WPS1 - Checking Pressure Sensors and Replacing them if Necessary (Workshop Campaign)

Vehicle Type: **Cayenne E-Hybrid (9YA / 9YB) / Cayenne S E-Hybrid (9YA / 9YB)**

Concerns: **Air conditioning system pressure sensors**

Installation position of pressure sensors

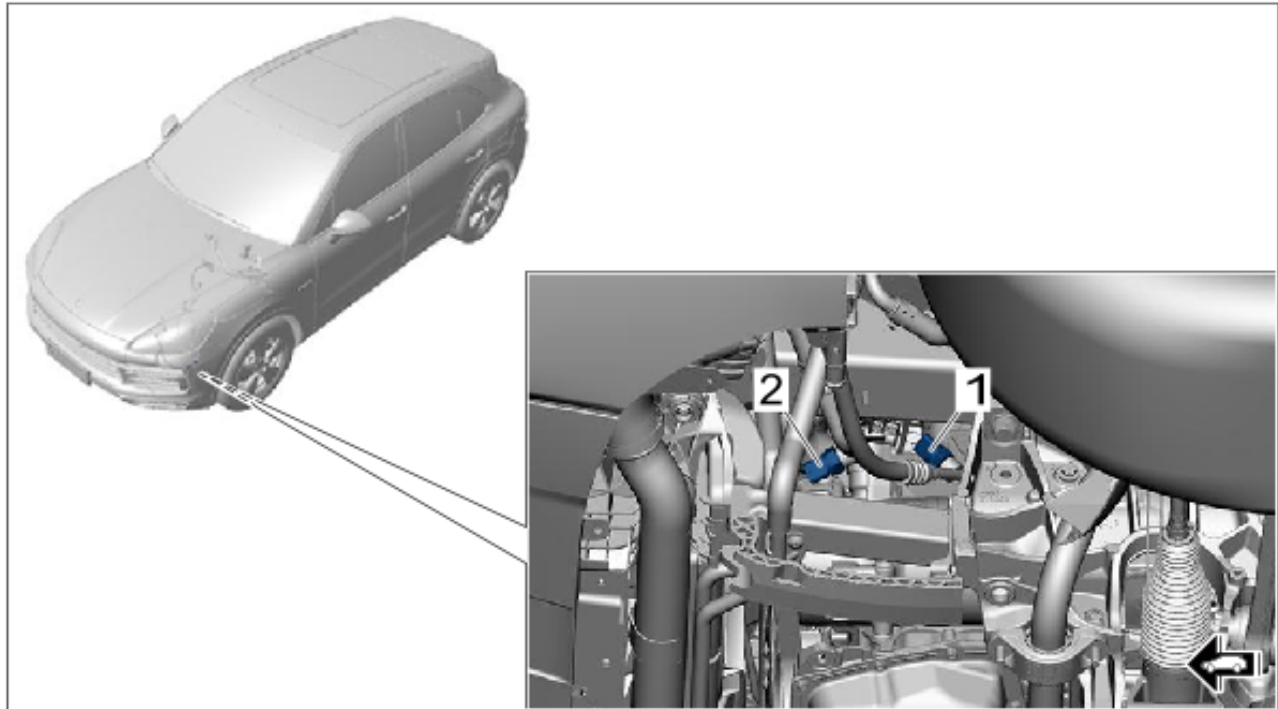
Cause: **Due to a manufacturing error at the supplier, pressure sensors for the refrigerant circuit that do not meet the required specifications were installed in the affected vehicles.**
 The failure of one or both pressure sensors in the refrigerant circuit therefore cannot be ruled out over the lifetime of the vehicle. As a result, there is a possibility that the air conditioning and battery cooling system are not functioning properly.

- 1 – Pressure sensor (PT1) on high-pressure side (**check and replace if necessary**)
- 2 – Pressure sensor (PT2) on low-pressure side (**check and replace if necessary**)

Action: Check pressure sensors and replace them if necessary.

New type of pressure sensor

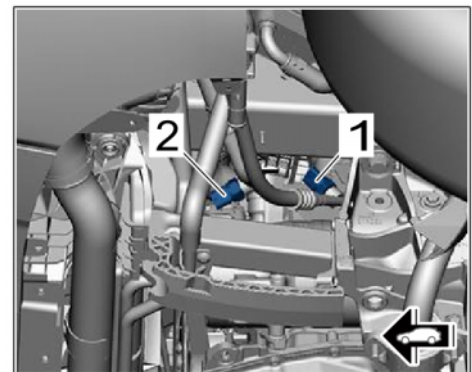
All pressure sensors with spare part number 4M0.959.603.**C** are **not OK** and must be **replaced**.

Pressure sensors with spare part number 4M0.959.603.**E** must also be checked from the applied production date.

- **up to** _41921 are **not OK** and must be replaced.
- **from** _42921 are **OK** and do **not** need to be replaced.

- 1 – Spare part index
- 2 – Production date from _42921 (S / D / CW / YY - Shift / Weekday / Calendar Week / Year). Shown in the image: 1st place not relevant / weekday 6 / calendar week 08 / year 2022
